Doors layout amendments &
Integration of Back Painted Glass on the East Elevation
Wuk_SK_PL_005

The following paragraphs set out the proposed changes and design rationale in more detail as an addendum to the approved Urban Design Report.

Integration of Back Painted Glass on the North Elevation
Wuk_SK_PL_006

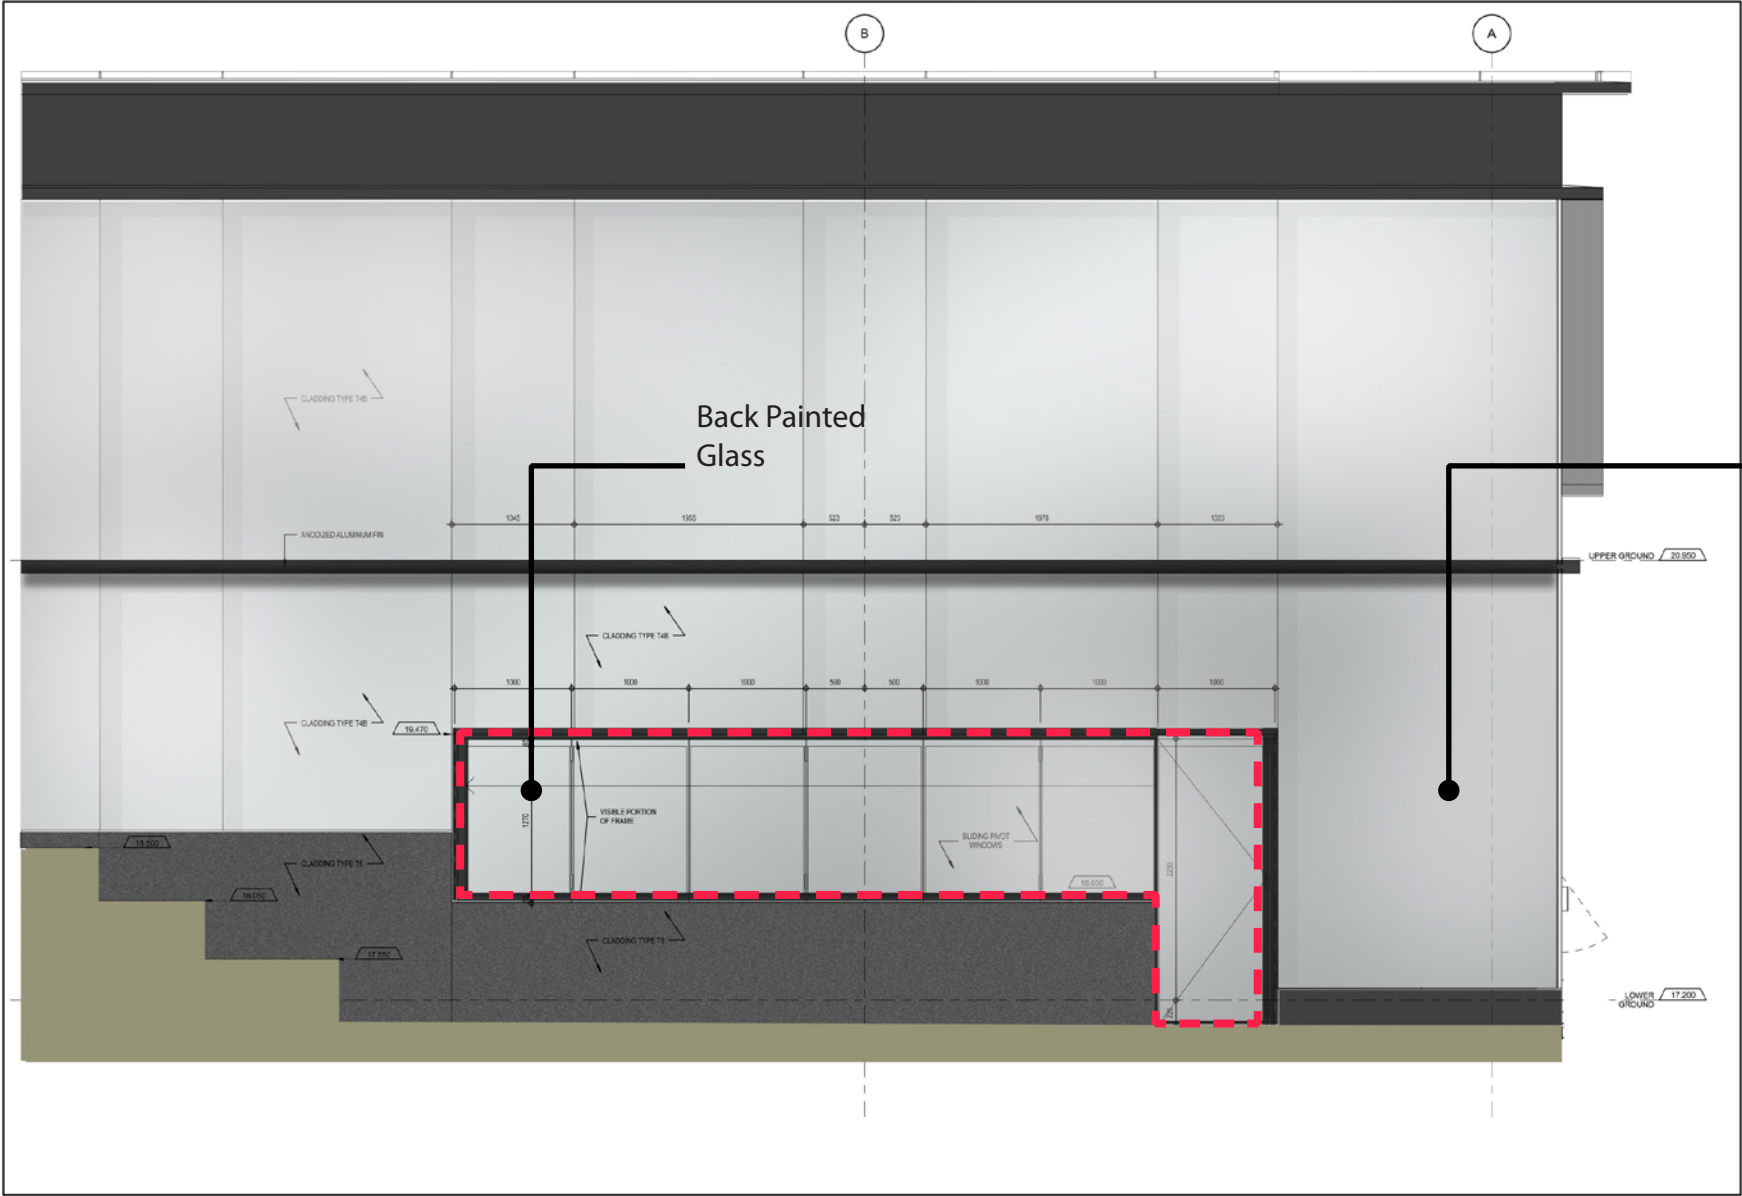
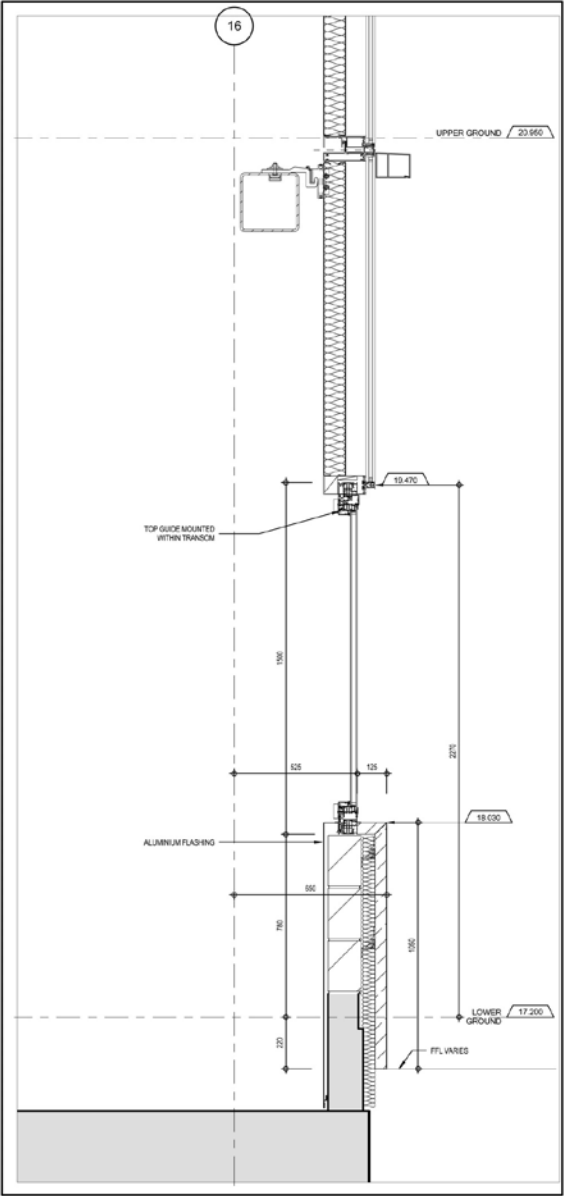
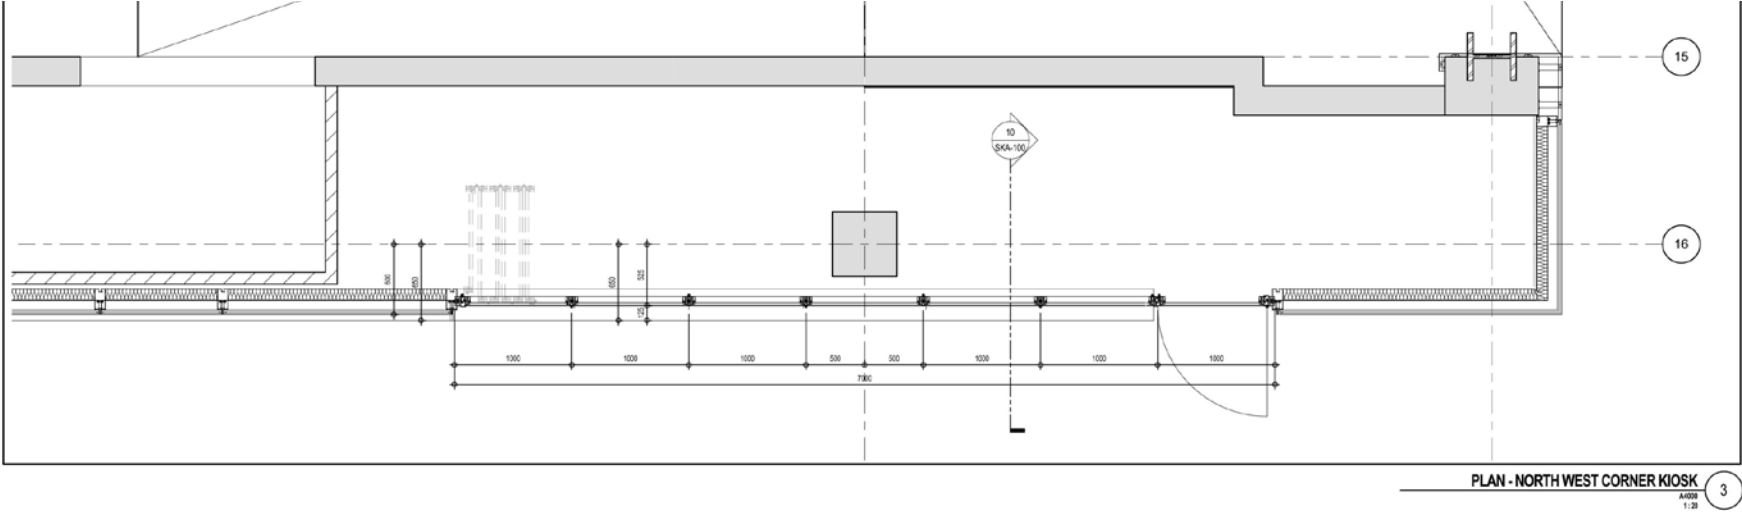
The door arrangements on both Lower and Upper Ground have been revised and rationalised.

Integration of additional shadow boxes on the West Elevation
Wuk_SK_PL_008

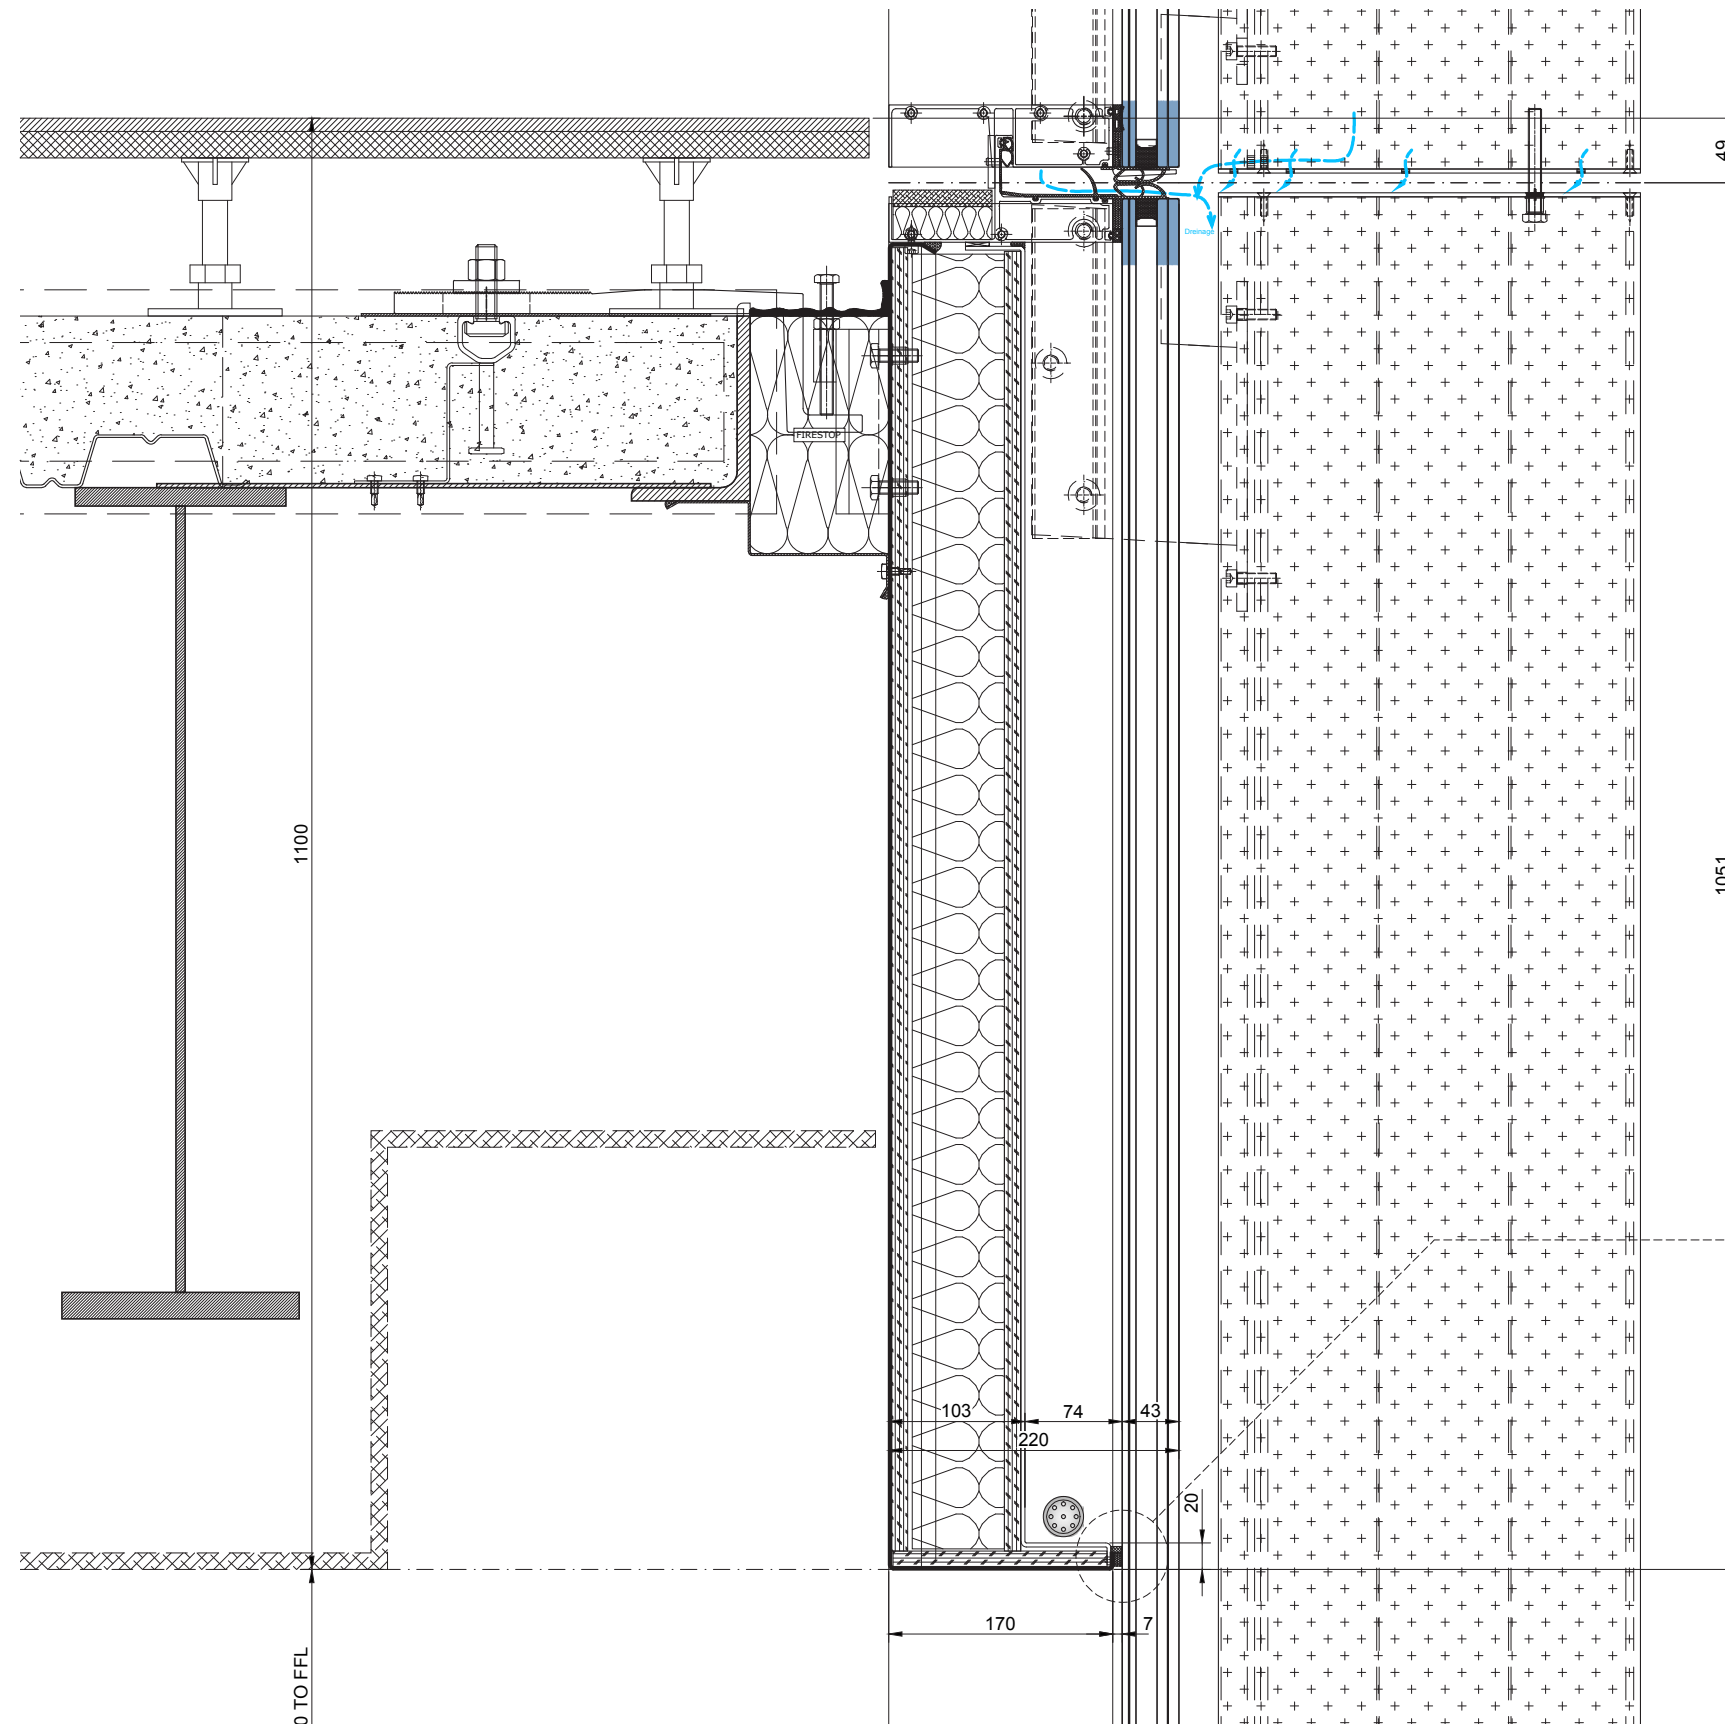
On the West Elevation, the glazed fractures have been reviewed and some shadow boxes have been inserted to meet the required acoustic performance of the curtain walling system. The visual appearance of these fractures remains the same as the shadow boxes merge into the glazing.

Integration of Louvres for future tenants within the facade reveal

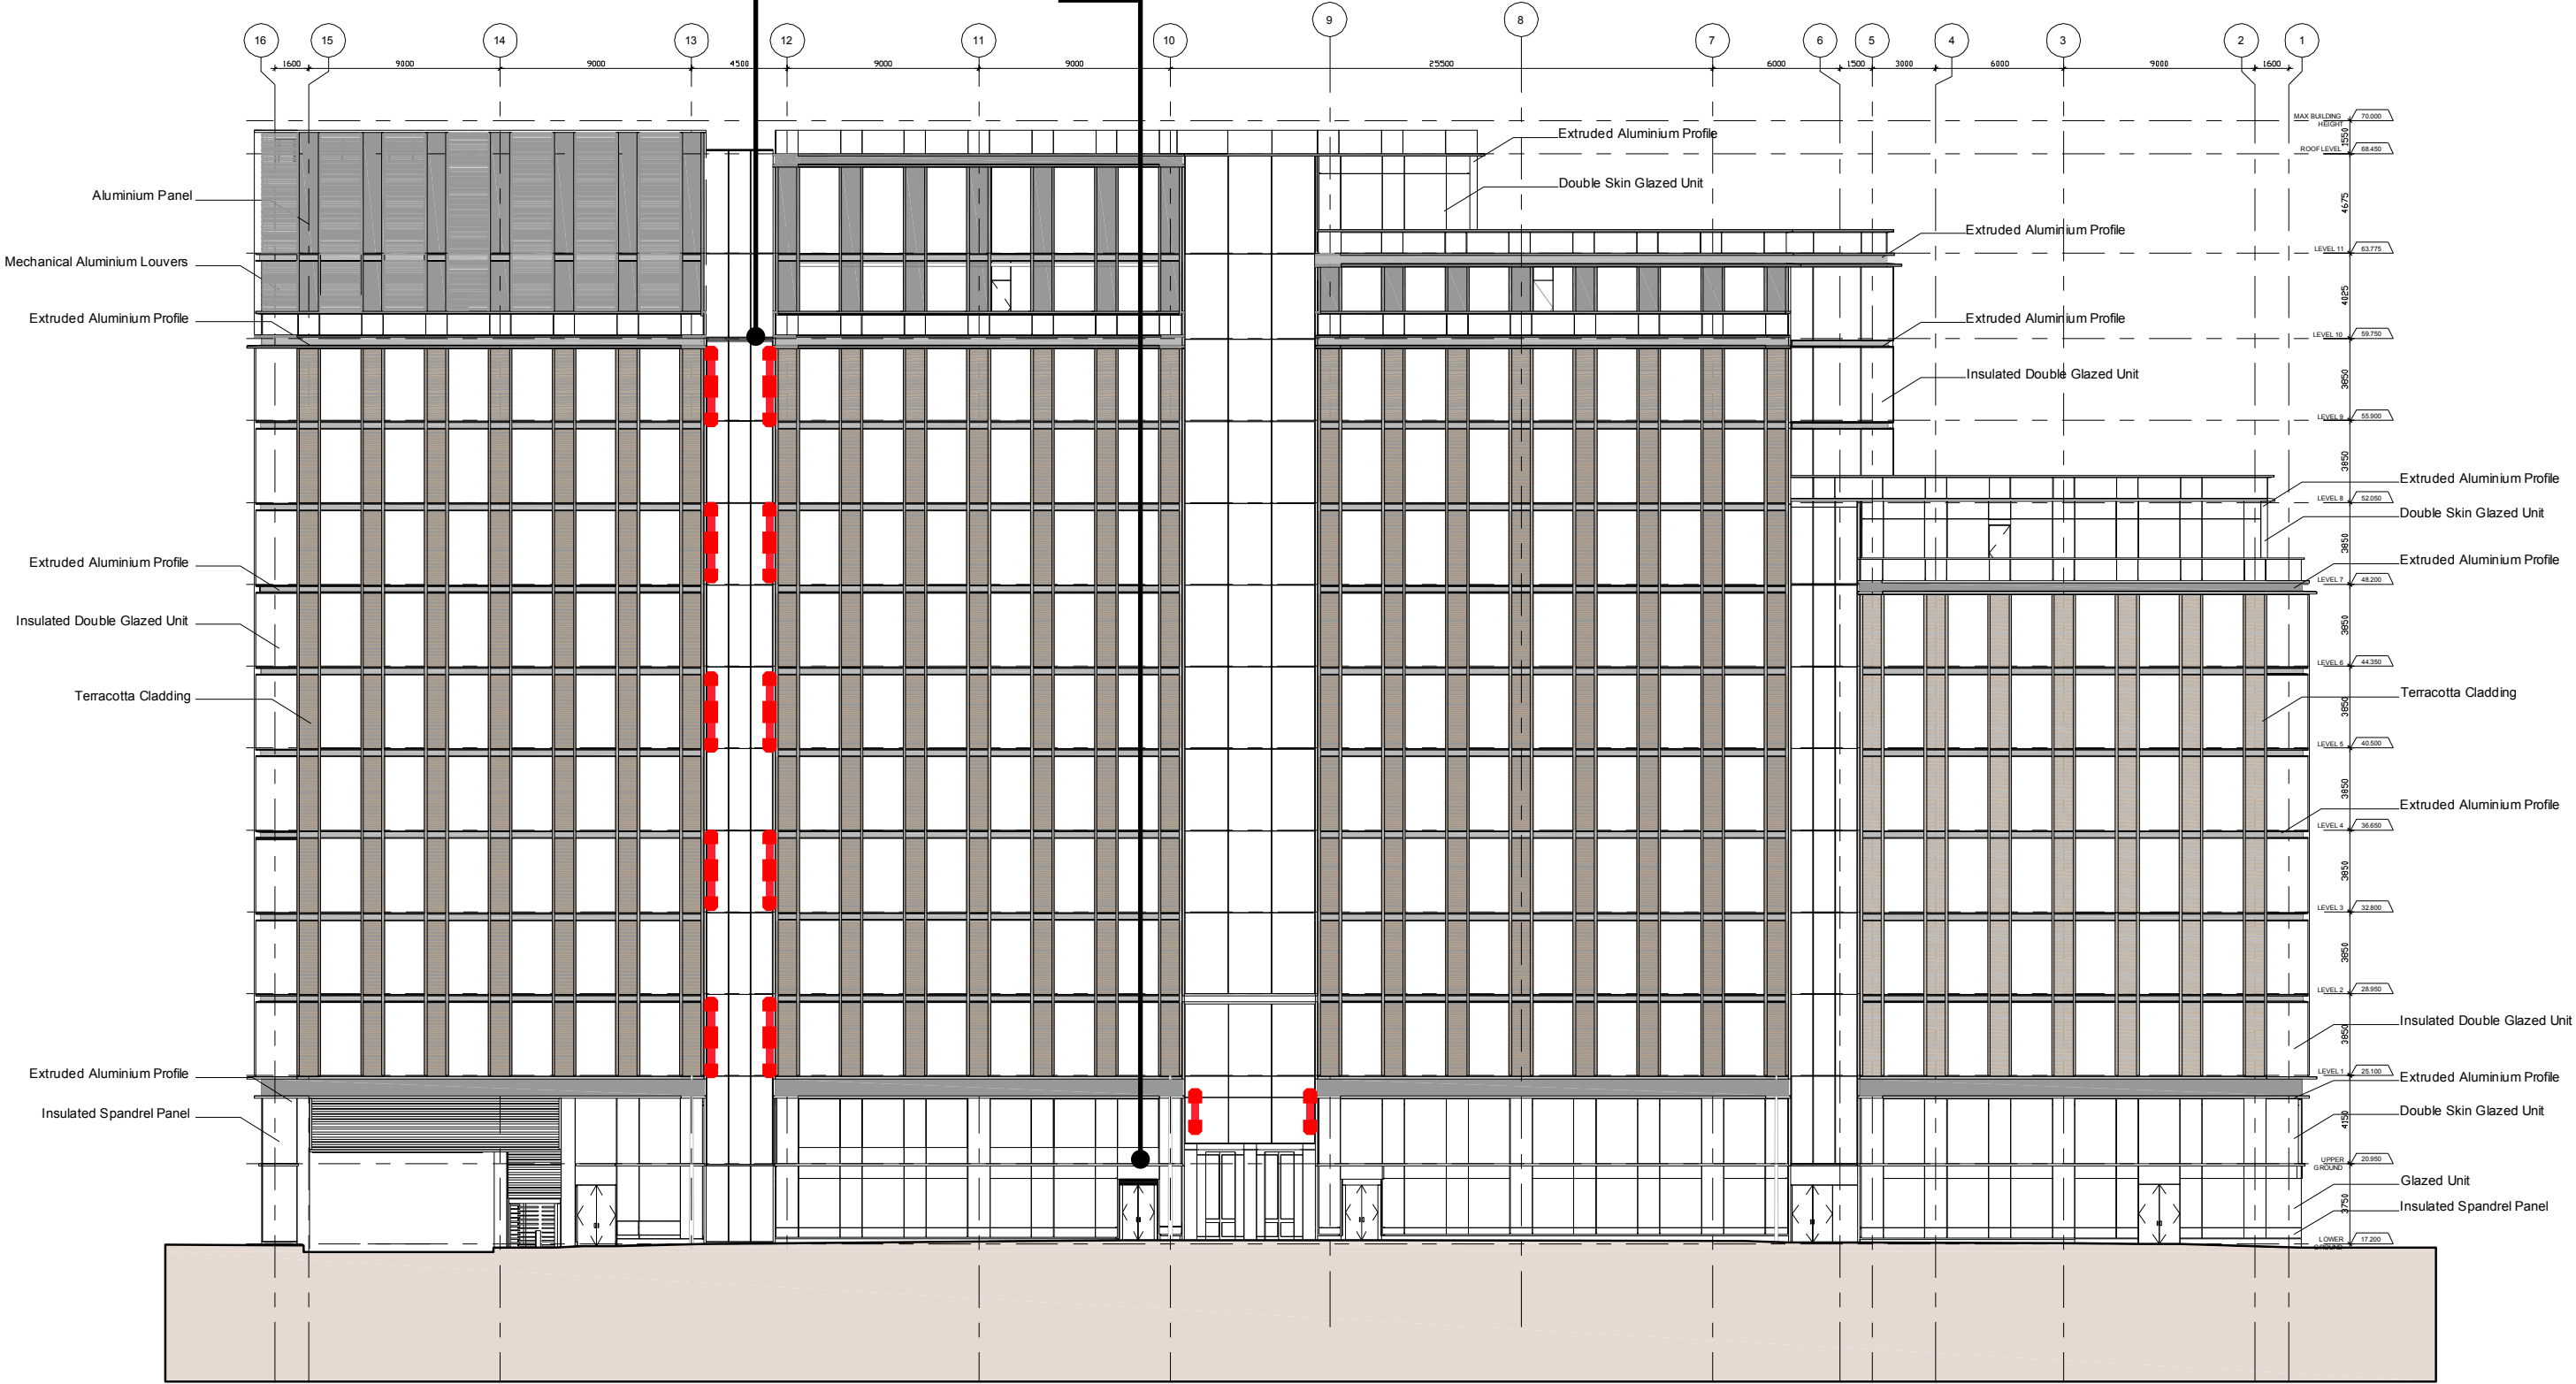
Some areas of louvres to facilitate future fit out works have been integrated with the reveals of the facade. The detail consists of some black anodised architectural louvres matching the finish of the adjacent panels.
